## Product Change Notification / SYST-28CLNB029

ERRATA - PIC18(L)F27/47K40 Family Silicon Errata and Data Sheet Clarifications Revision

## PIC18(L)F27/47K40 Family Silicon Errata and Data Sheet Clarifications

Figure 1. 28-pin SPDIP, SSOP, SOIC

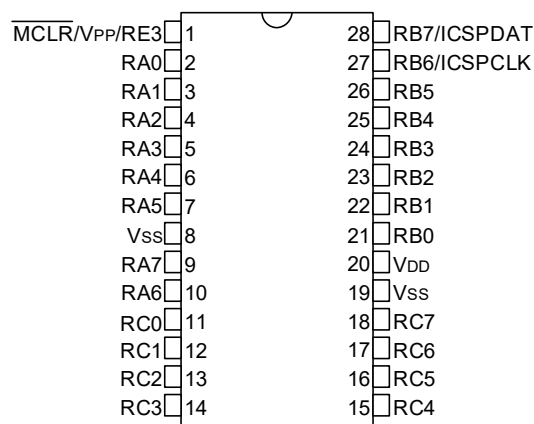
The correct marking for pin 26 on the 28-pin SPDIP/SSOP/SOIC package is **RB5**.

Figure 3. 40-pin PDIP

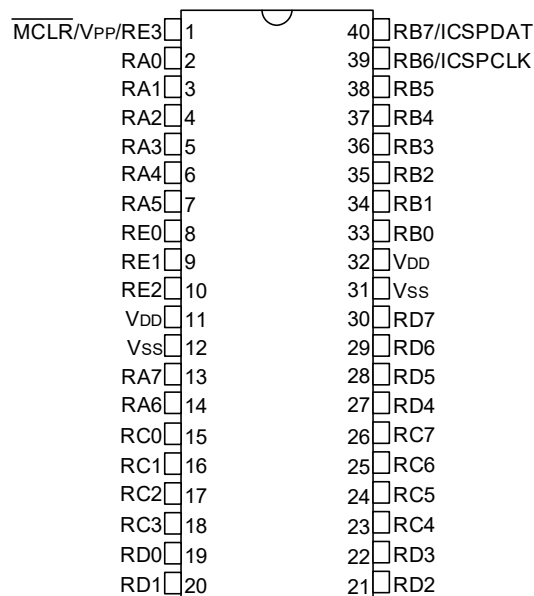
The correct marking for pin 38 on the 40-pin SPDIP package is **RB5**.

**Figure 38-10: ADC Conversion Timing (ADC Clock  $F_{OSC}$ -Based)**

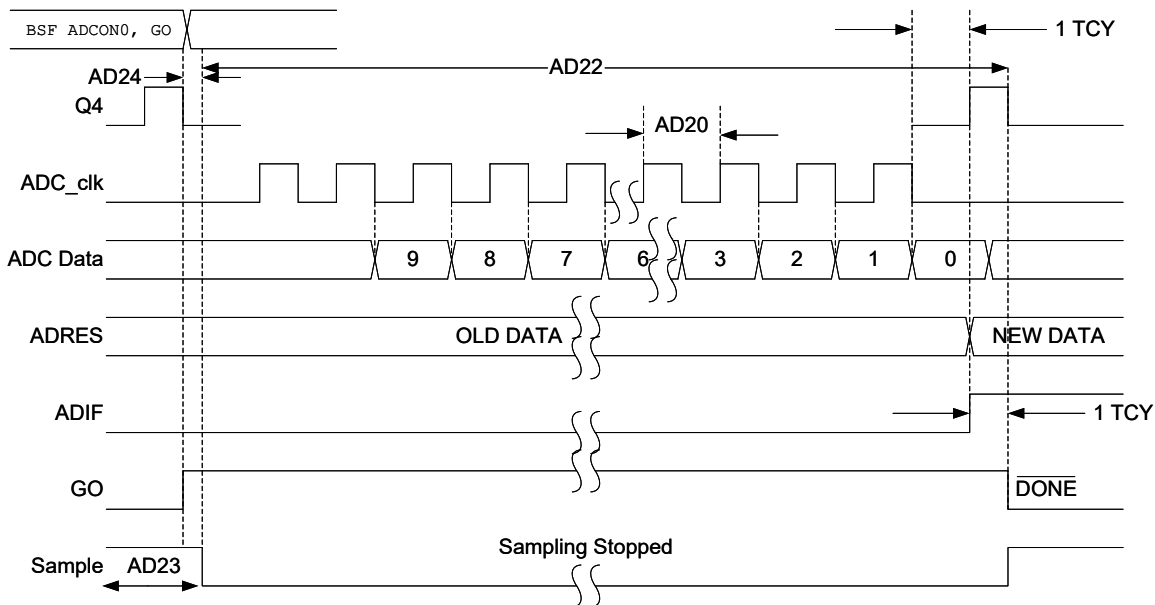
Refer to the images below for corrections of Figure 38-10 and Figure 38-11. Previously, the parameter numbers were incorrect.
